RS-04-005

Dresden Nuclear Power Station, Units 2 and 3
Facility Operating License Nos. DPR-19 and DPR-25
NRC Docket Nos. 50-237 and 50-249

Quad Cities Nuclear Power Station, Units 1 and 2
Facility Operating License Nos. DPR-29 and DPR-30
NRC Docket Nos. 50-254 and 50-265

Subject: Request for Amendment to Technical Specifications Surveillance
Requirements for the Main Steam Line Relief Valves and Associated Relief
Requests

Figure 1

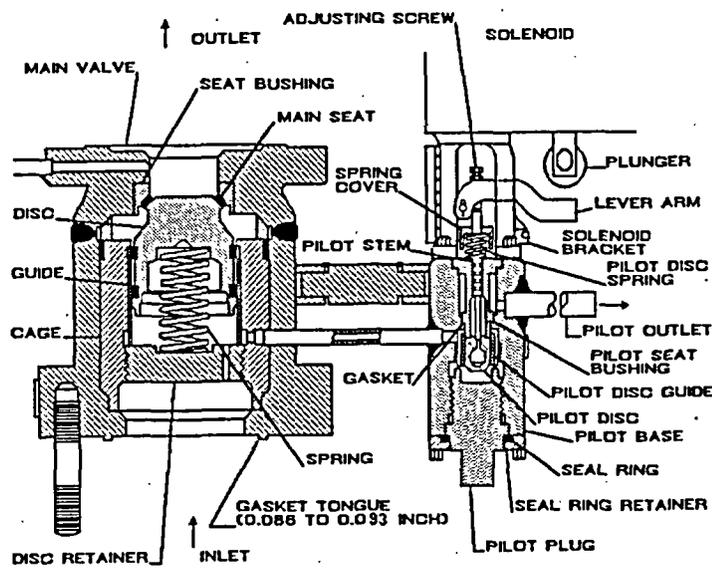
For the ERVs, the actuator test will be performed with the pilot valve actuator mounted in its normal position. This will allow testing of the manual actuation electrical circuitry, solenoid actuator, pilot operating lever, and pilot plunger. This test will verify pilot valve movement. However, since this test will be performed prior to establishing the reactor pressure needed to overcome main valve closure spring force, the main valve will not stroke during the test.

The valve actuator testing at DNPS and QCNPS includes manual dry cycling of the pilot valve to verify that the stem travel and lever arm adjusting screw gap are within limits. Following this verification, the ERV solenoid will be energized to manually stroke the pilot valve. The stem travel and lever arm adjusting screw gap will then be rechecked to verify that these parameters are within limits following the dry cycling. Partial disk-stem separation caused by dry cycling of the pilot valve will be detected during this recheck. Discussions with the ERV manufacturer, Dresser, concluded that this recheck would detect partial disk-stem separation caused by dry cycling of the pilot valve. In addition, EGC has performed dry cycling of the pilot valves at DNPS and QCNPS for many years, with no signs of partial or full disc detachment. Therefore, the proposed testing is adequate to detect the partial disk-stem separation experienced at Nine Mile Point during the simulated bench test described in the NRC inspection report.

overcome the pilot spring force. The proposed testing for the DNPS and QCNPS ERVs will include manual actuation of the electrical circuitry, solenoid actuator, pilot operating lever, and pilot plunger after installation in the plant. However, since this test will be performed prior to establishing the reactor pressure needed to overcome main valve closure spring force, the main valve will not stroke during the test. Since the proposed testing for DNPS and QCNPS ERVs includes a manual actuation of the solenoid and pilot valve, the test will demonstrate that the solenoid force is adequate to overcome the pilot spring force. Resistance checks of the cutout switch will assure the solenoid is capable of producing its full output force.

Figure 2

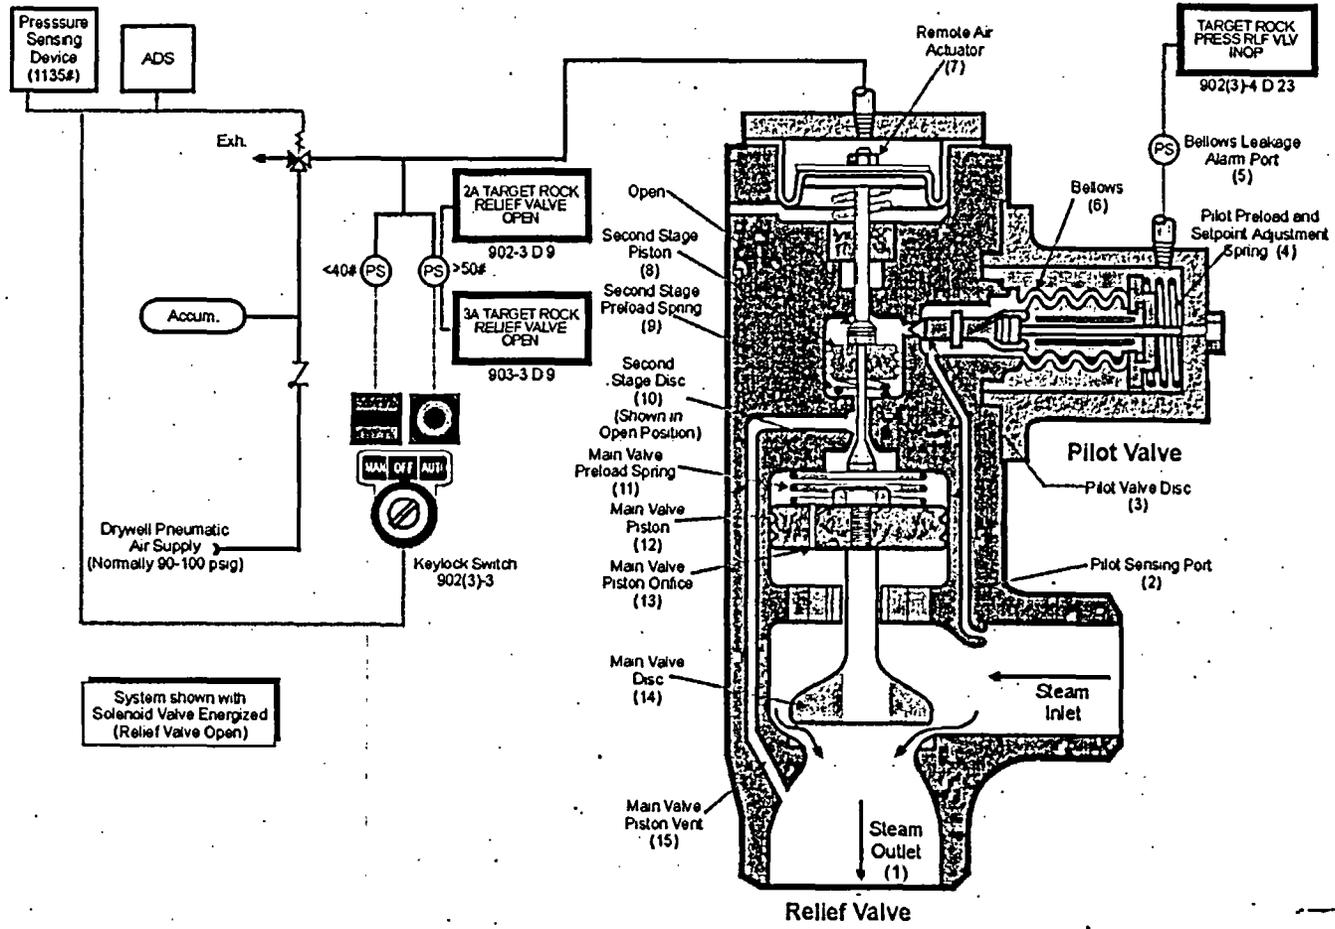
stage disc. Actuation of the plunger during plant operation allows pressure to be vented from the top of the main valve piston. This allows reactor pressure to lift the main valve piston, which opens the main valve disc. The test will verify movement of the plunger in accordance with vendor recommendations. However, since this test will be performed prior to establishing the reactor pressure needed to overcome main valve closure spring force, the main valve will not stroke during the test.
